Safety Recall Notice

ROCKY MOUNTAIN RECALLS BICYCLES WITH FRONT DISC BRAKES TO REPLACE QUICK RELEASE LEVER DUE TO CRASH HAZARD <http://www.cpsc.gov/en/recalls/2016/rocky-mountain-recalls-bicycles-with-front-disc-brakes-to-replace-quick-release-lever/>

Quick release lever on recalled bikes opened too far.

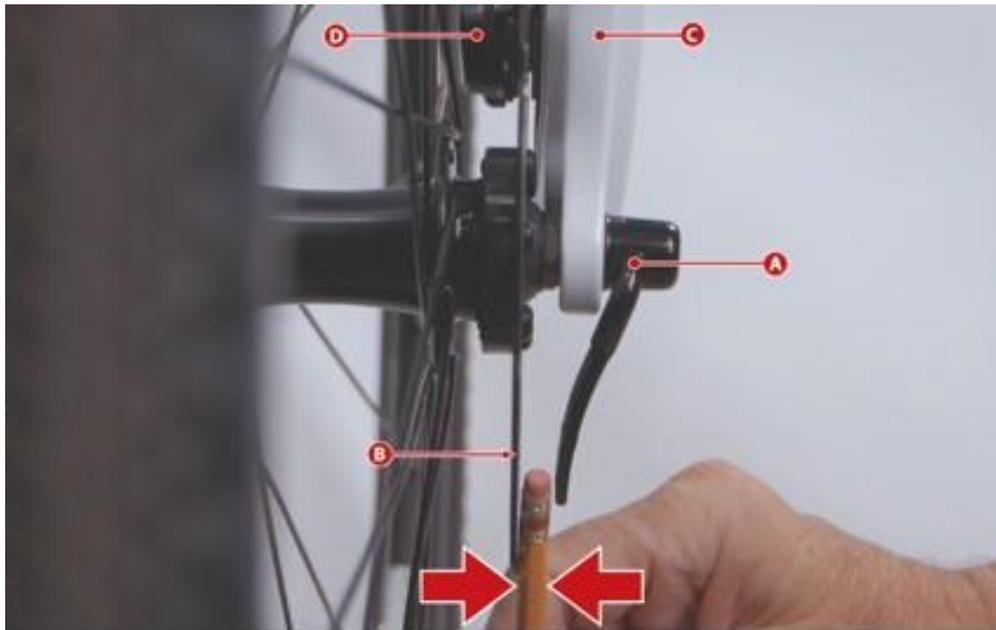
REPLACE YOUR SKEWER IF:

- QUICK RELEASE LEVER OPENS TOO FAR
- MAY GET CAUGHT IN THE BRAKE ROTOR
- FRONT WHEEL MAY SUDDENLY LOCK UP

YOUR SKEWER IS FINE IF:

- QUICK RELEASE LEVER OPENS CORRECTLY
- 6 MM ROTOR CLEARANCE WHEN LEVER IS FULLY OPEN

Replacement quick release lever opens with sufficient clearance.
